SEAD-59 AND SEAD-71

PROJECT SCOPING PLAN FOR PERFORMING A CERCLA
REMEDIAL INVESTIGATION/FEASIBILITY STUDY (RI/FS) AT
THE FILL AREA WEST OF BUILDING 135 (SEAD-59), AND THE
ALLEGED PAINT DISPOSAL AREA (SEAD-71), SENECA ARMY
DEPOT ACTIVITY

APRIL 1997

**PROJECT SCOPING PLAN
REMEDIAL INVESTIGATION/FEASIBILITY STUDY
AT SEAD-59 and SEAD-71
SENECA ARMY DEPOT ACTIVITY
ROMULUS, NEW YORK**

FIGURE 4-4
 LOCATION OF EXISTING AND PROPOSED SAMPLING POINTS AND SURVEYS

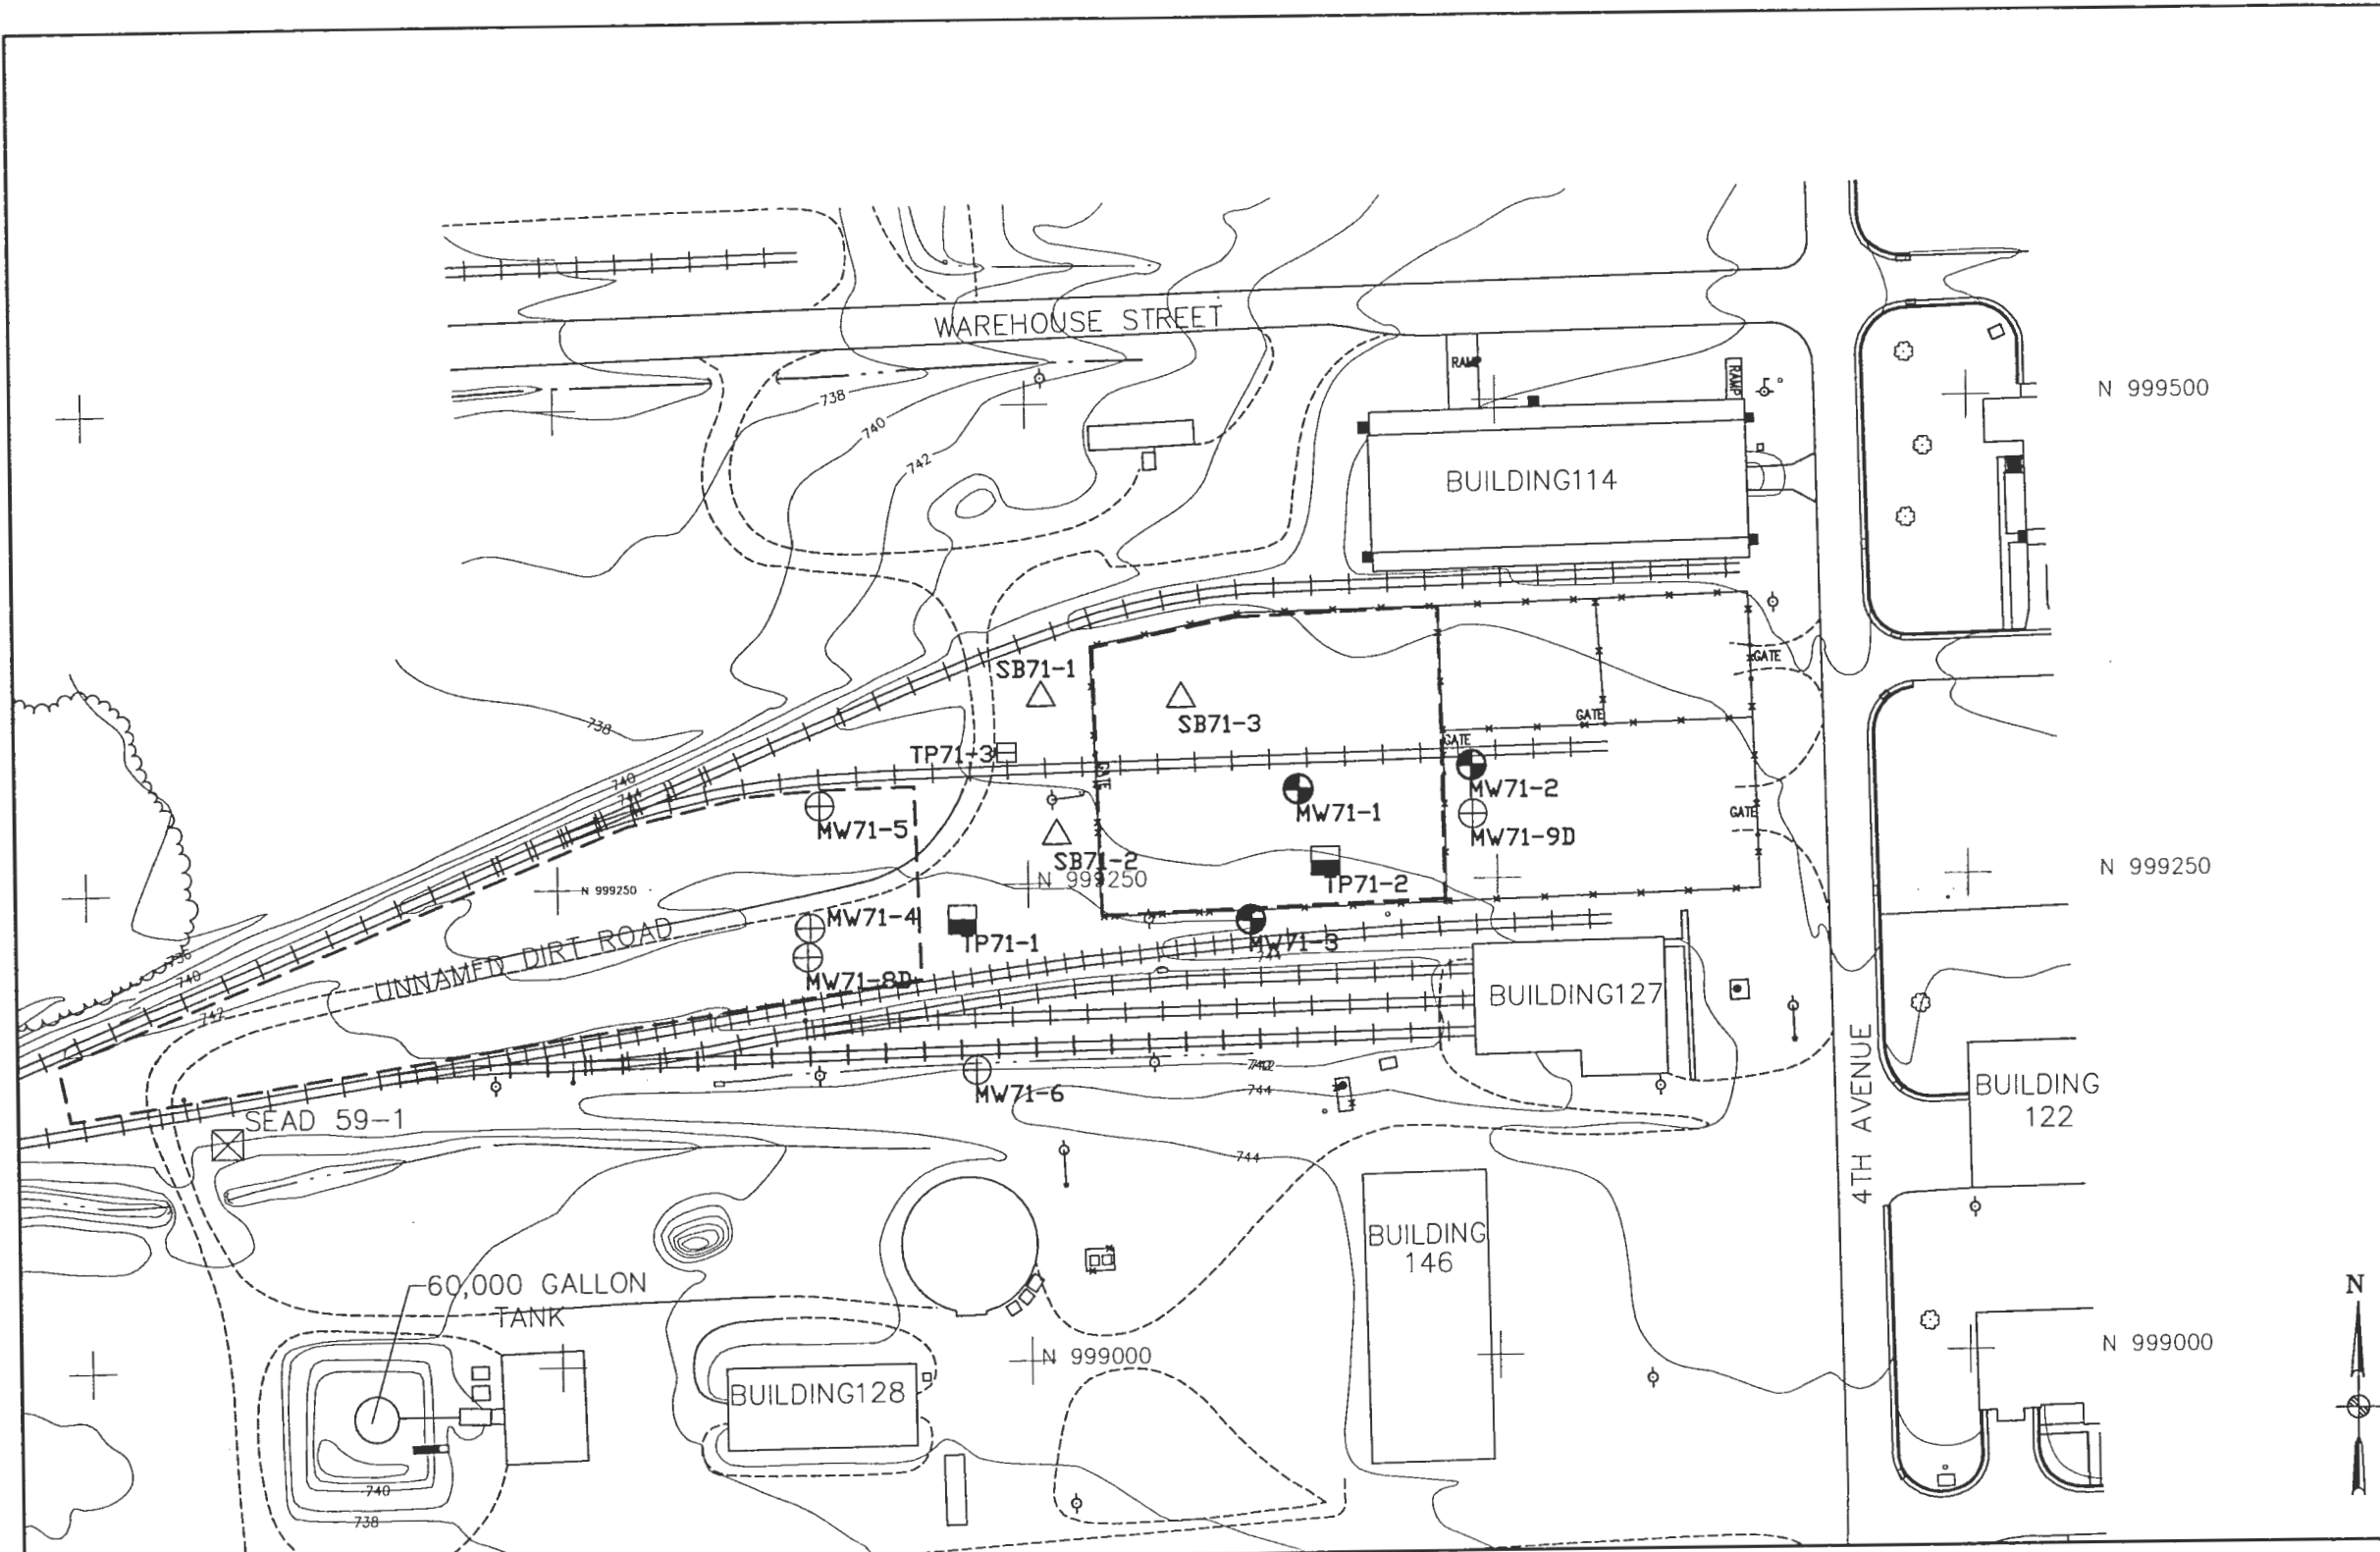
- Comment #18** Figure 4-5: Groundwater contours should be shown on this Figure. Comparison of this Figure with Figure 3-19 indicates that the proposed monitoring wells may only monitor part of the area which is hydraulically downgradient of the SEAD. Figure 3-19 indicates that groundwater flow is to the west-southwest. The proposed monitoring wells are all located to the west of the SEAD. An additional monitoring well should be installed to the south of the rail lines leading to Building 127 to the south of Test Pit TP71-1 to monitor groundwater quality downgradient of the SEAD.

- Response #18** Agreed. An additional well has been proposed for the location recommended in the comment. But, we do not believe that it is necessary to show the groundwater contours on this map because this would make the map look cluttered and more difficult to read; however, the groundwater contours are shown on Figure 3-15. The new well was added to the text in Section 4.3.3 and it was added to Figure 4-4.

Response #21 Agreed. One bedrock monitoring well was proposed for SEAD-71 to address vertical impacts to groundwater. One bedrock well will be installed in a downgradient location in the west-central portion of the site adjacent to an overburden well. This well, and the three bedrock wells at SEAD-59, will be used to define the direction of groundwater flow in bedrock for this area. The text in Section 4.3.8 was revised to show this change and the well was added to Figure 4-4 of the Scoping Plan.

The additional GPR survey to be performed in the central and western portion of the site was added to the text in Section 4.3.1 and the location of the GPR geophysical survey is indicated on Figure 4-4. The soil sampling program in Section 4.3.2 of the Scoping Plan was revised and appropriate changes were made to Figure 4-4.

Response #21 Agreed. One upgradient, shallow bedrock monitoring well has been added to SEAD-71. The text on pages 4-22, 4-23, and 4-27 has been modified accordingly, and Table 4-2, and Figure 4-4 have also been updated to reflect this new well.
